# Riley Park LAP Resident Feedback

Alison Shaw

# Proposed Amendments for 19<sup>th</sup> st NW between 2<sup>nd</sup> and 6<sup>th</sup> ave NW

Image 1

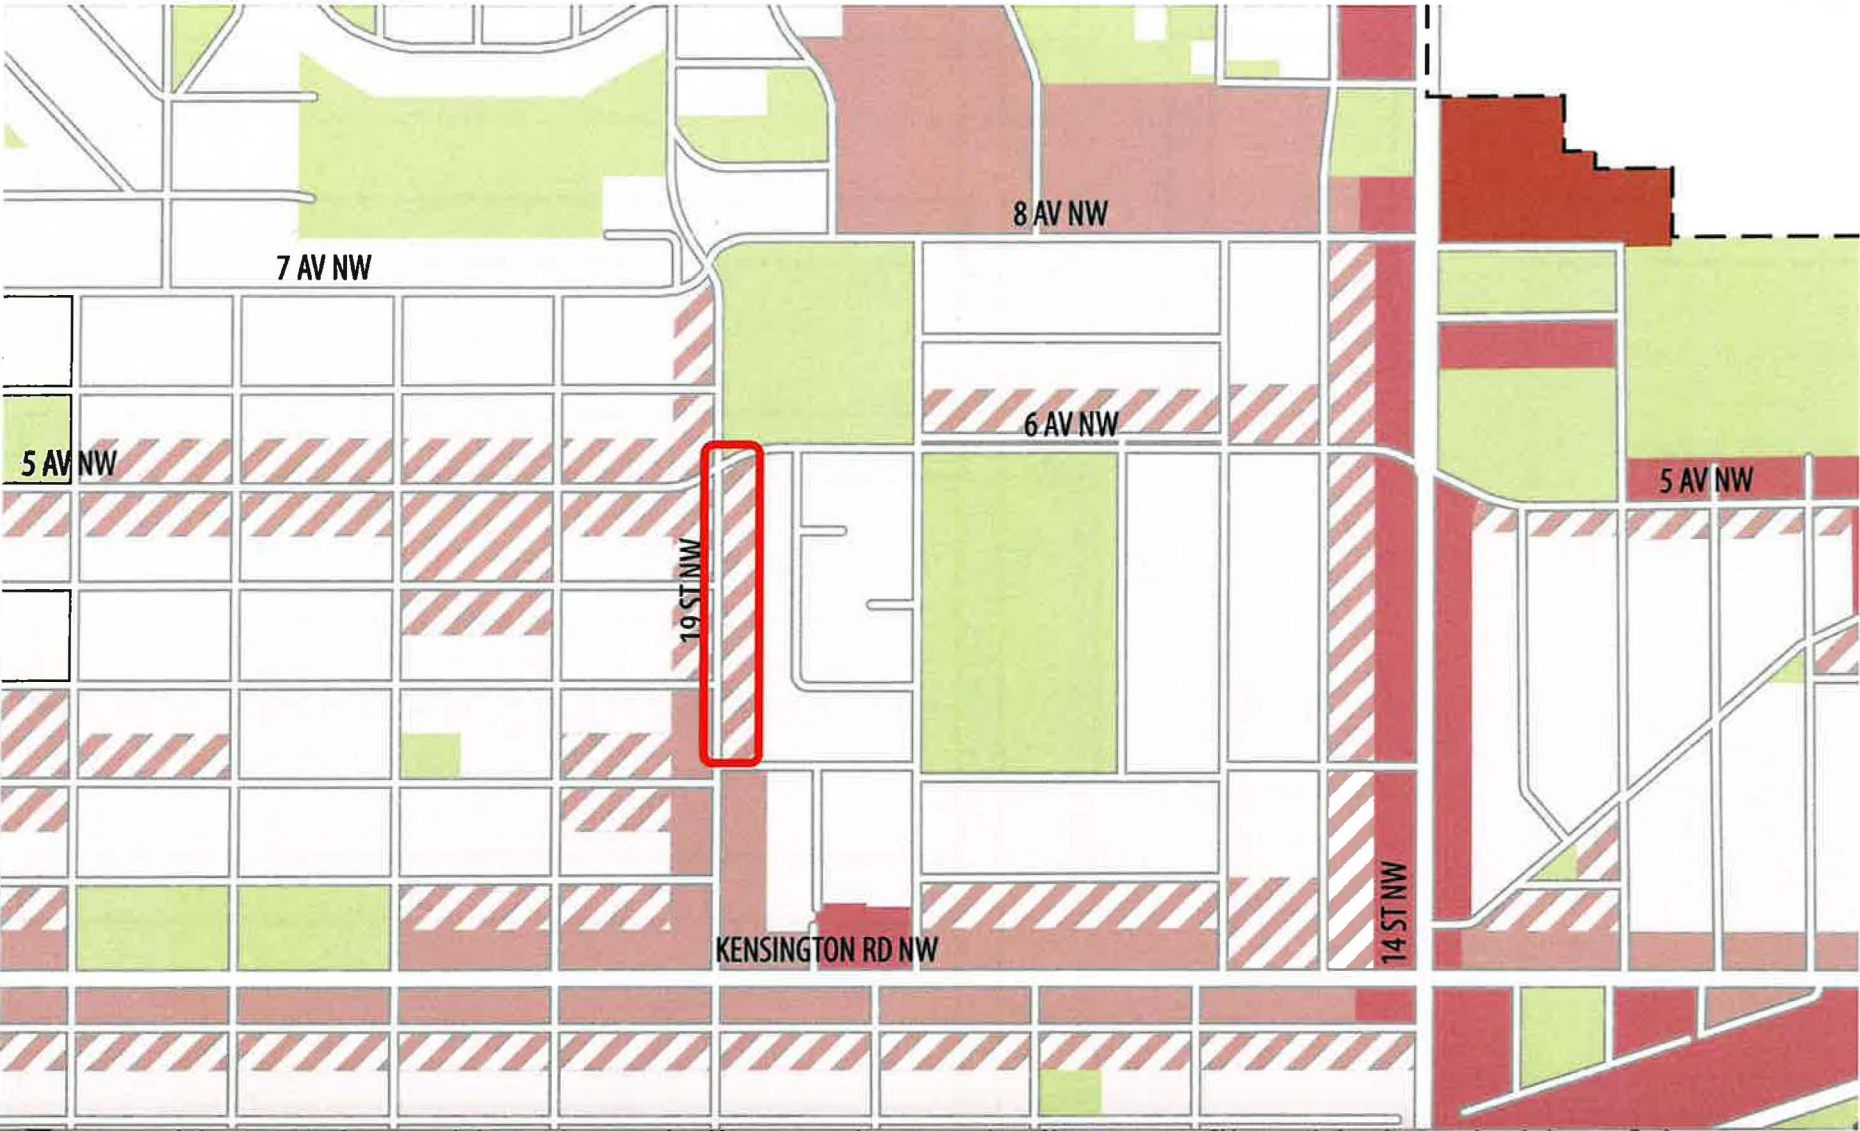
As you can see when reviewing Images 1, 2 and 3, the areas that have been identified as Neighbourhood Connectors with the building scale “low-modified” all have a back lane for access. For example:

**19<sup>th</sup> street NW between 2<sup>nd</sup> and 6<sup>th</sup> ave NW is the only stretch of street proposed to be classified in this way that does not have a back lane**

- 1. Reclassify the urban form to “Neighbourhood Local,” which is the same classification that has been identified for other residential areas of the Riley Park LAP that do not have a back lane**
- 2. Change the building scale for this stretch of street to “Limited (up to 3 stories)”**

Image 4

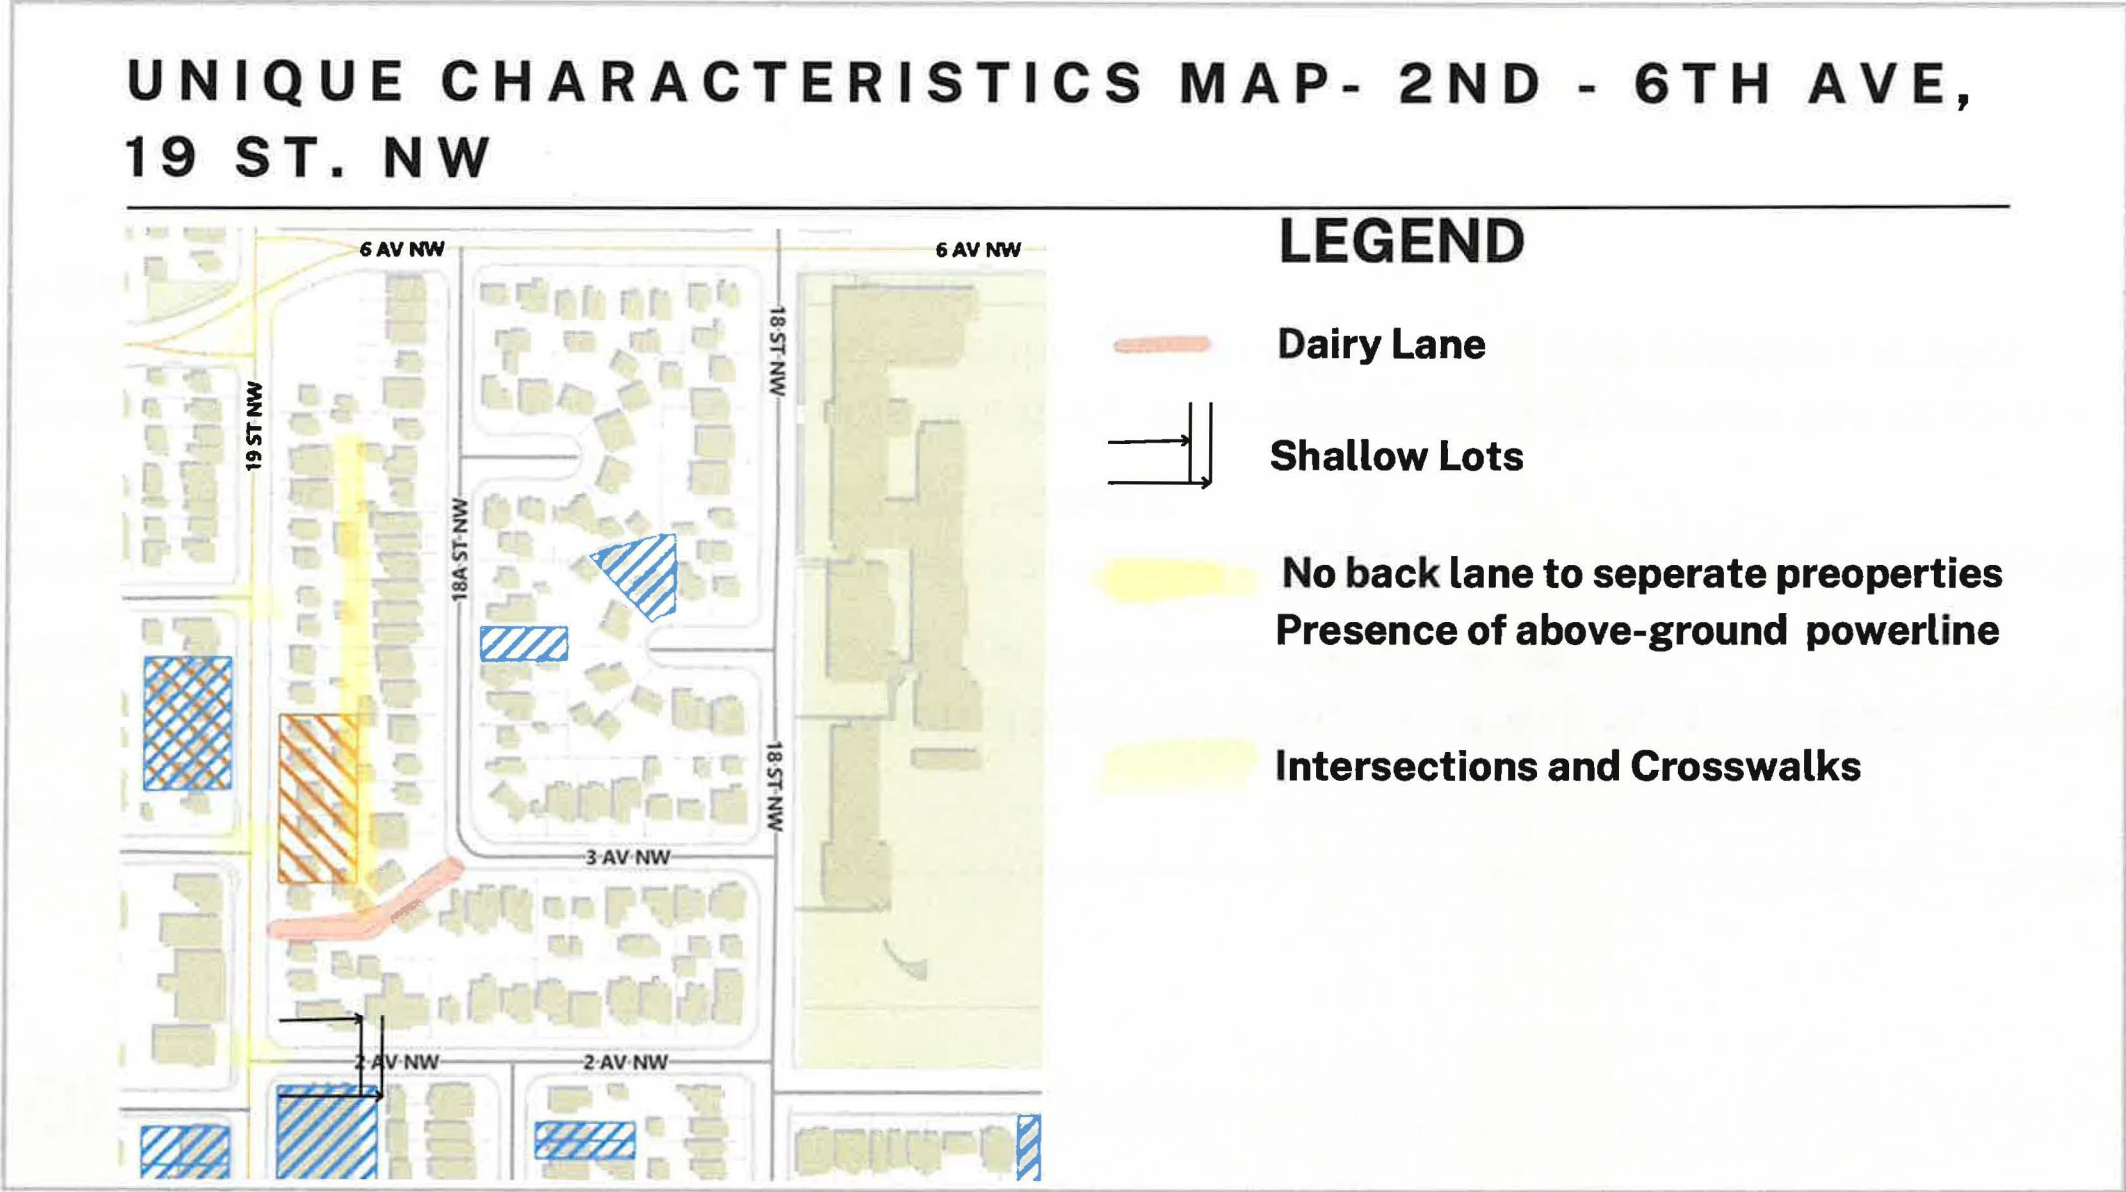
- These lots are shallower than the typical 120' by 50' lots
- This stretch is a busy pedestrian area due to having “Dairy Lane” at one end
- Includes 3 Frequently used crosswalks for pedestrians. In addition to local residents getting out for a walk in the neighbourhood, many pedestrians are using these crosswalks and sidewalks to access Queen Elizabeth school, the West Hillhurst Community centre and its associated fields and outdoor swimming pool, the local off-leash dog park, as well as the businesses on 19<sup>th</sup> street NW
